# CITY OF ALBUQUERQUE

**Re: Clean Machine Carwash**  
**4200 San Mateo Blvd., NE**  
**Traffic Circulation Layout**  
Engineer's/Architect's Stamp **6-9-16** (G18-D049)

Based upon the information provided in your submittal received 7-19-16-16, the above referenced plan cannot be approved for Building Permit until the following comments are addressed:

SITE

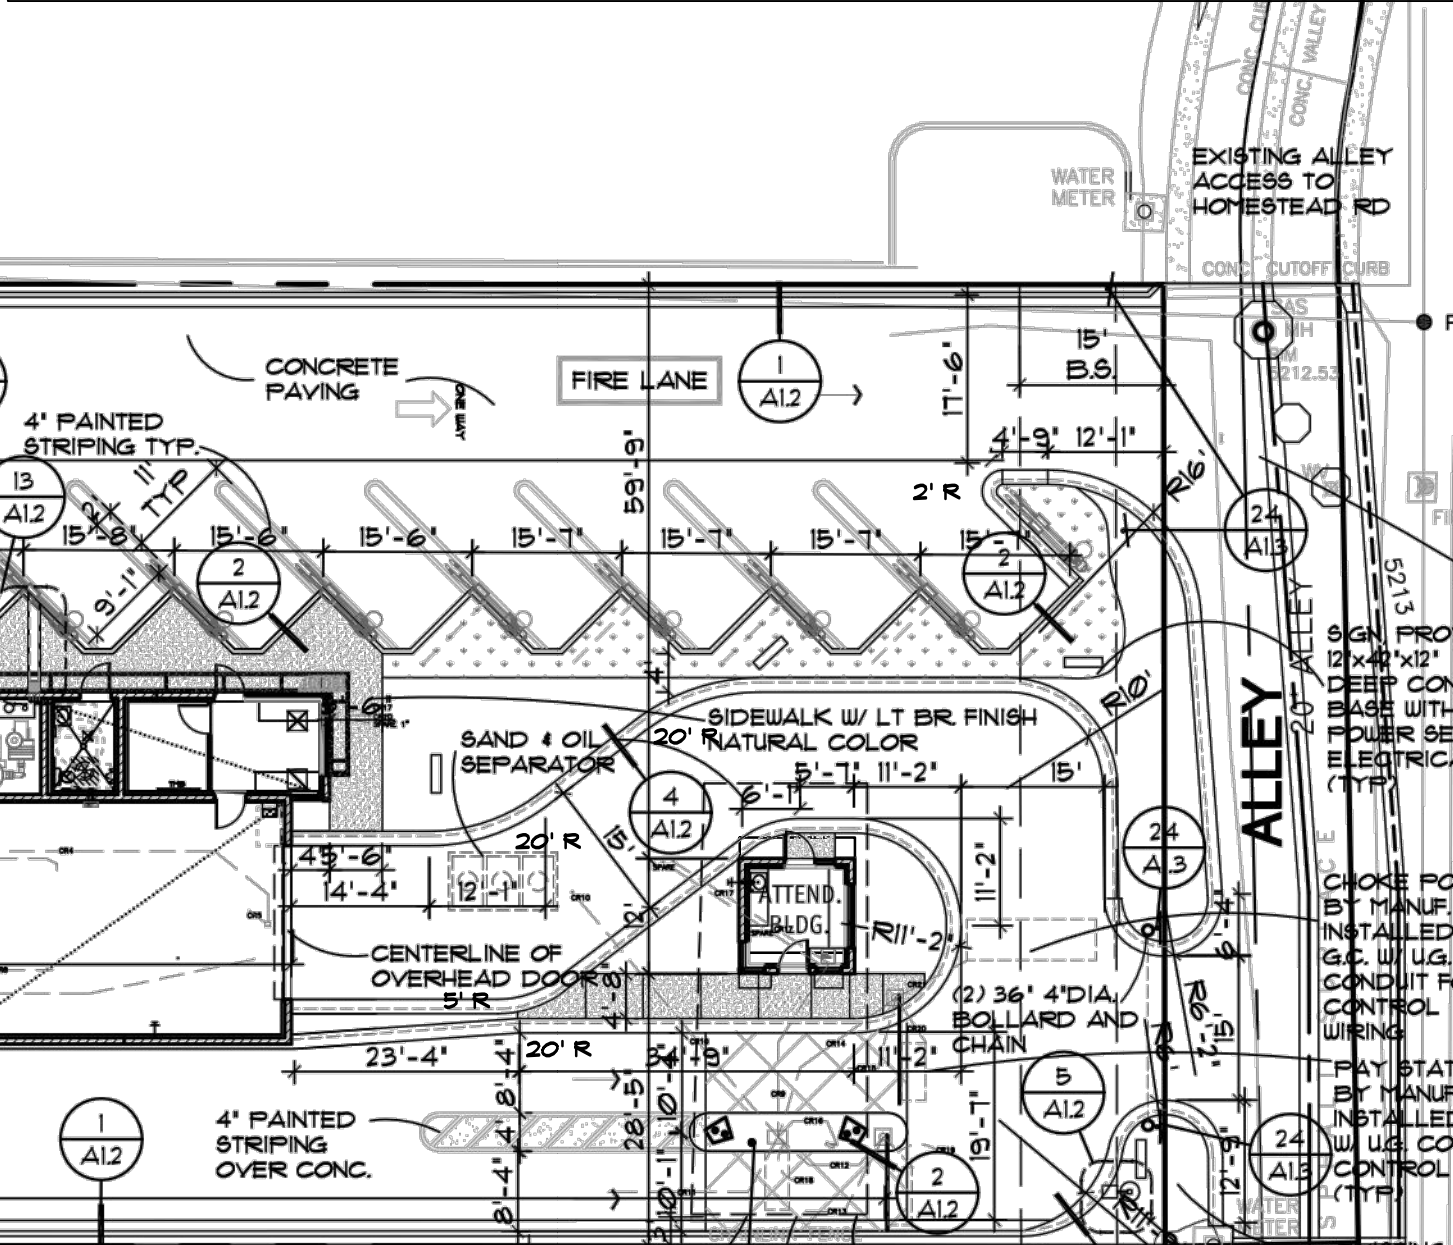
1. Please provide the Detail Sheets labeled on the TCL submittal.
2. Clarify circulation of vehicles at the main entrance on San Mateo Blvd. There appears to be conflicting vehicle movements. Please add detail of directional arrows and signage.

3. The curb cut on San Mateo should be a maximum of 40 ft. wide.
4. Please identify and dimension all proposed, doors, structures, sidewalks, curbs, drive pads, ADA ramps, walls and anything that influences the parking and circulation on the site.

5. Identify the right of way width, medians, curb cuts, and street widths on San Mateo Blvd.
6. Detail and dimension bicycle and motor cycling parking spaces, along with appropriate signage.

7. Dimension the length of the handicap accessible space.
8. The ADA accessible parking sign must have the required language per 66-7-352.4C NMSA 1978 **"Violators Are Subject to a Fine and/or Towing."** Please call out detail and location of HC signs.

9. Per DPM, a 6 ft. wide ADA accessible pedestrian pathway is required from the public sidewalk to the building entrances. Please clearly show this pathway and provide details of ramps from ROW.

10. Provide a min 6" or max 8" high concrete barrier curb or other acceptable barrier between landscaping and parking areas and/or drive aisles. Please call out detail and location of barrier curb. Please call out this detail.

11. One-way vehicular paths require pavement directional signage and a posted **"Do Not Enter"** sign at the point of egress. Please show detail and location of posted signs.
